Technical Bulletin N°03

REFERENCE BT_2017_FR20_03_UK

SUBJECT New Formula Renault 2.0 Solenoid + On-board Video Camera loom protection

1. 2017 Solenoid - OPTIONAL

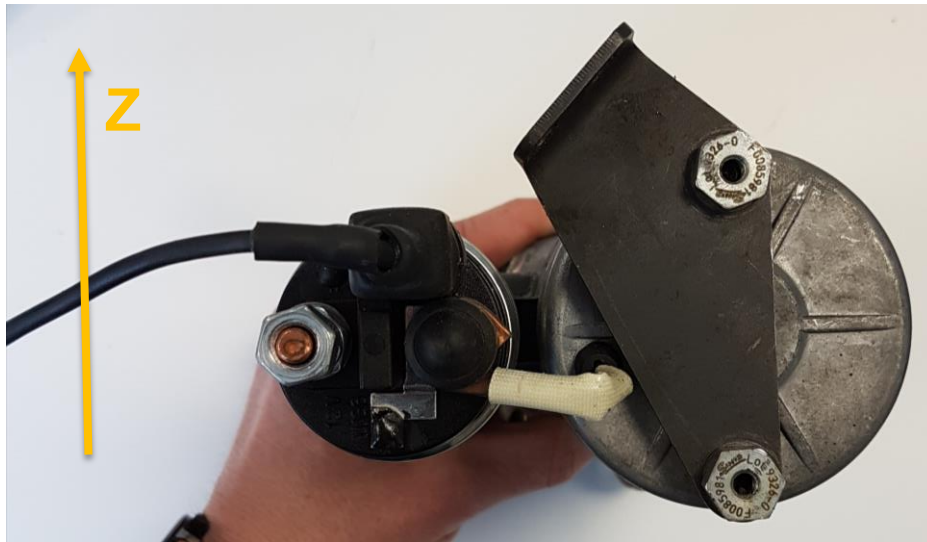
Renault Sport Racing introduces a new starter solenoid for 2017 season. This new solenoid has been design with our supplier in order to stop repetitive breakage occurred with old version.

This new solenoid is delivered ready to plug into the engine loom. This new solenoid is equipped with a remote connector (superseal 282103-1). Renault Sport Racing asks you to pay attention of the mounting direction: the connection where we have plug the remote connector is on top, switched over compared to previous versions.

- Reference: 82 01 710 991
